The Real Costs of Cleaning Up Nuclear Waste

Appendix A: Erosion and Control of Erosion at the West Valley Nuclear Site

Erosion and Control of Erosion at the West Valley Nuclear Site

Figure 8. Projected Erosion Fronts at 500 years
 (maintaining McKinney's convex longitudinal-profile retreat)

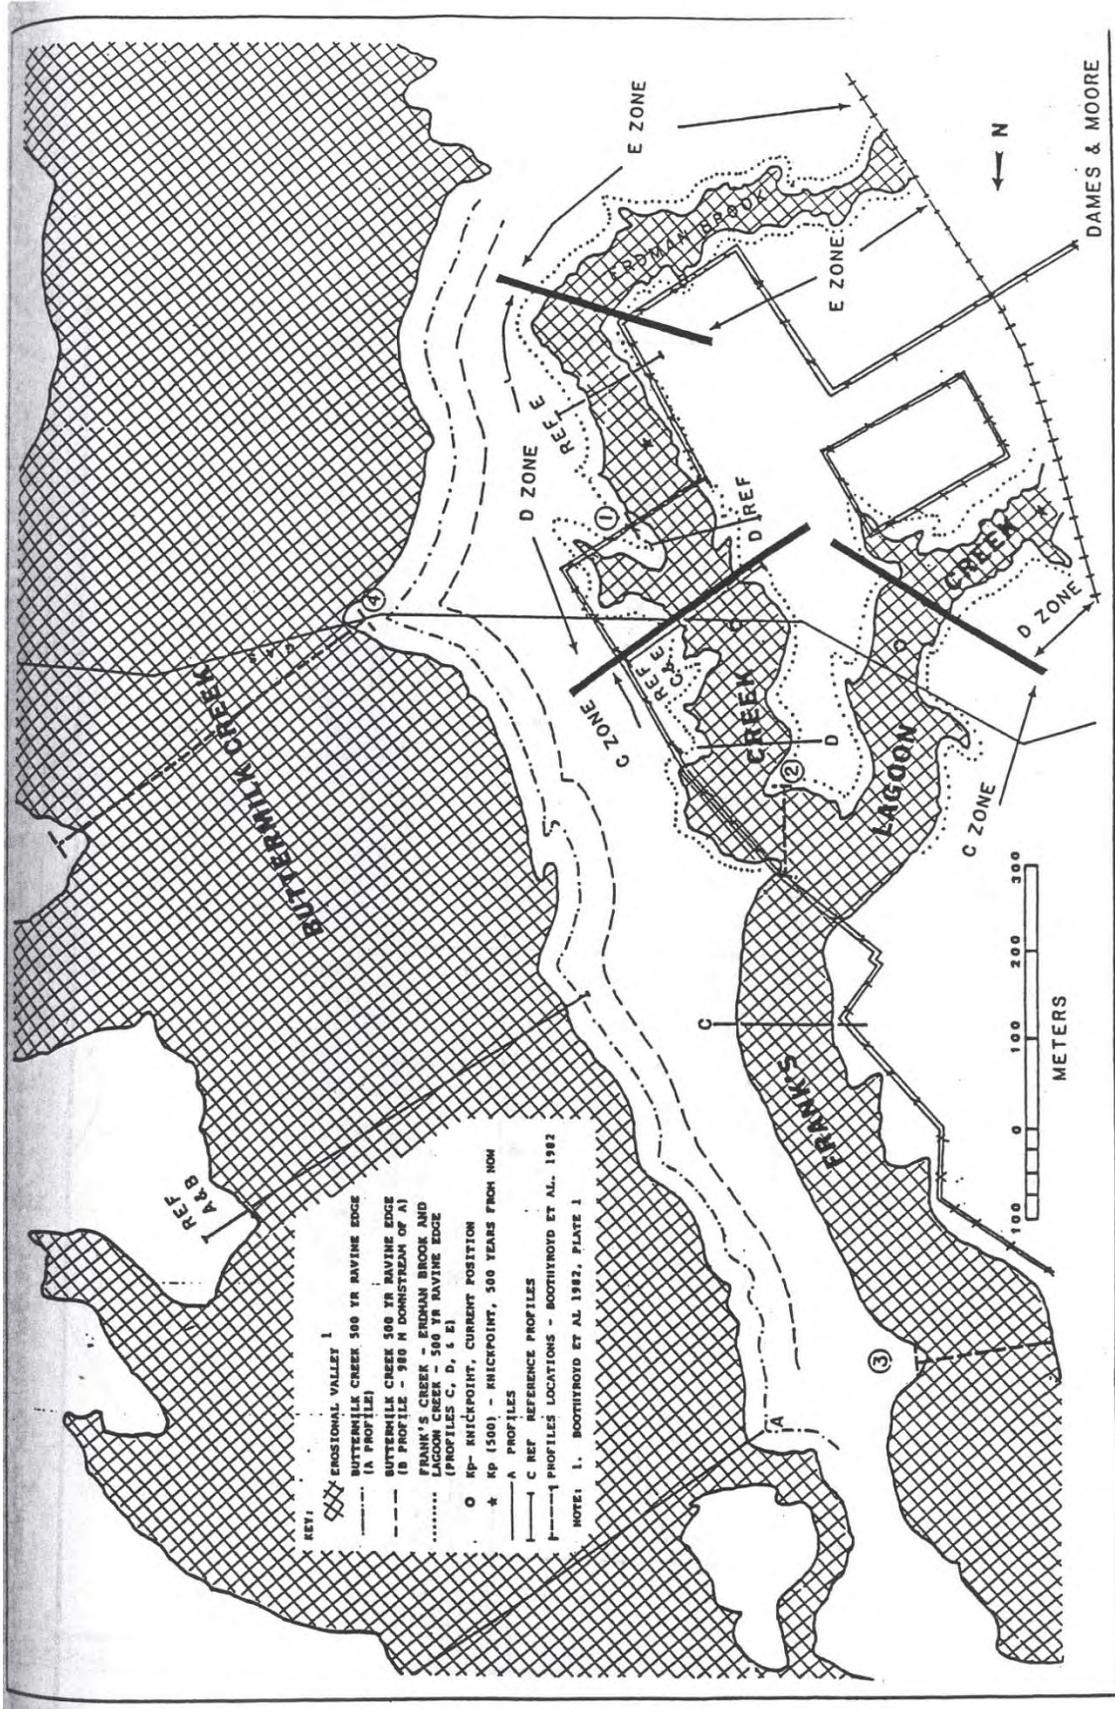
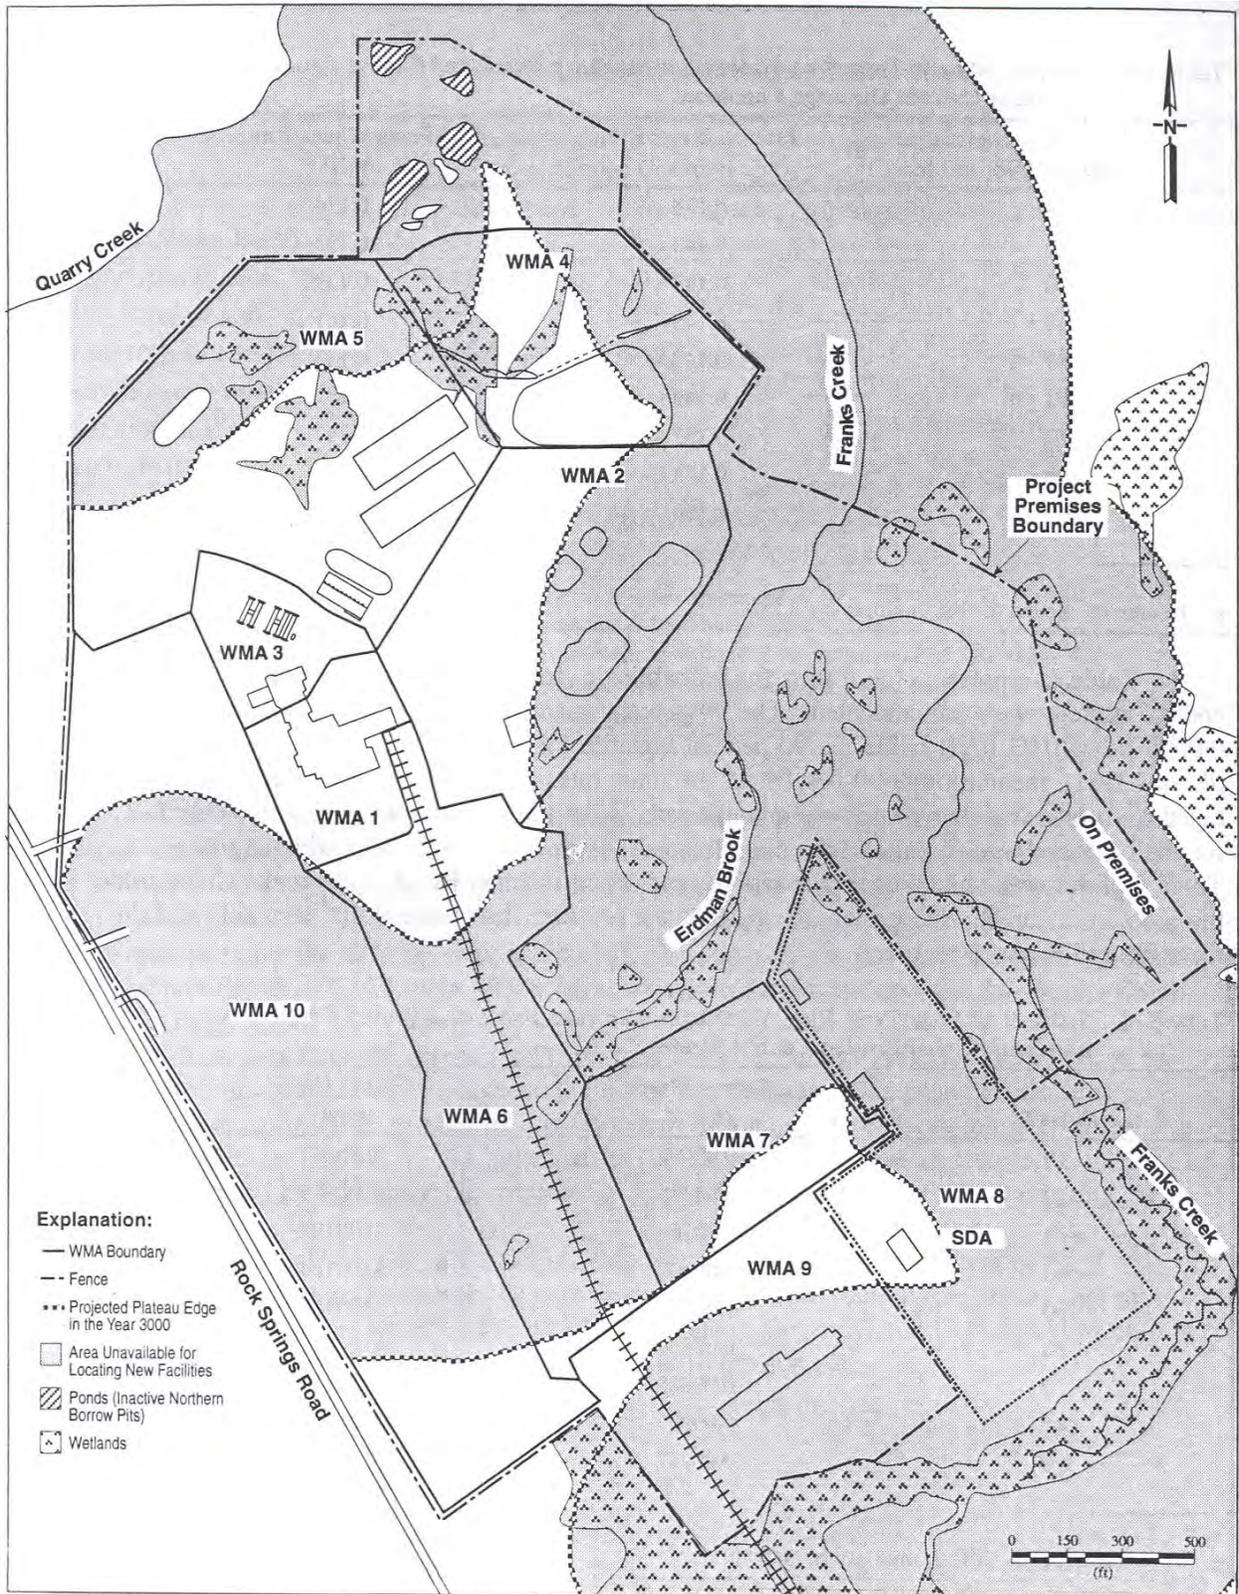
uniformly up gradient to and into tributaries. This method caused him to transpose longitudinal profiles laterally to reflect his down-cutting rate. The 1993 EID (Vol. III, Part 3) used McKinney's down-cutting and slope retreat rates to project gully erosion and provided plateau-edge retreat maps for 50 years (EID Figure 5-6 p. 128) and 500 years (EID Figure 5-4 p. 126). Figure 8 reproduces the 1993 EID (Fig. 5-4, p. 126) map projections of the range in positions for plateau edges 500 years into the future. Initiation of new tributary gully heads by erosive seepage, or otherwise, will enhance the risk indicated by the mapped future edges.

While both LaFleur's recent terrace age approach and McKinney's transposition approach have merit, their methods' applications beyond Buttermilk Creek into Franks Creek have a fatal flaw that will grossly underestimate future erosion. The flaw is that the Franks longitudinal profile will not only shift while down-cutting proceeds, but the longitudinal profile will also convert sooner or later from convex into a concave-up shape. Whether this transformation of shape will take several hundred or a few thousand years is not clear, but great down-cutting is implied (Figure 3), with attendant side-slope retreat.
